TO: Mercedes-Benz Dealer Principals, General	FROM: Gregory Gunther, Department Manager,
Managers, Sales Managers, Service Managers, Parts	Vehicle Compliance and Analysis, Engineering
Managers	Services
RE: Recall Campaign Launch Notification 2018050012 Retrofit Headlamp Sealing Caps MY17 213 (E-Class)	DATE: June 1, 2018

Campaign No. 2018050012, June 2018

SUBJECT: Model 213 Model Year 2017 Retrofit cover for headlamp adjustment screws at left and right

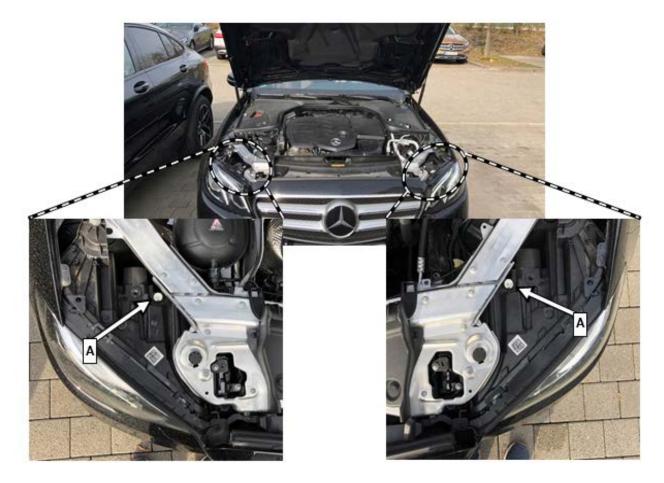
Daimler AG ("DAG"), the manufacturer of Mercedes-Benz vehicles, has determined that on certain E-Class vehicles (213 platform) the horizontal adjustment mechanism might be accessible and therefore not meet the requirement of Federal Motor Vehicle Safety Standards (FMVSS). An authorized Mercedes-Benz dealership will retrofit headlamp sealing caps on the affected vehicles.

- 1. Open engine hood.
- 2. Retrofit cover (A) for headlamp adjustment screws at left and right.
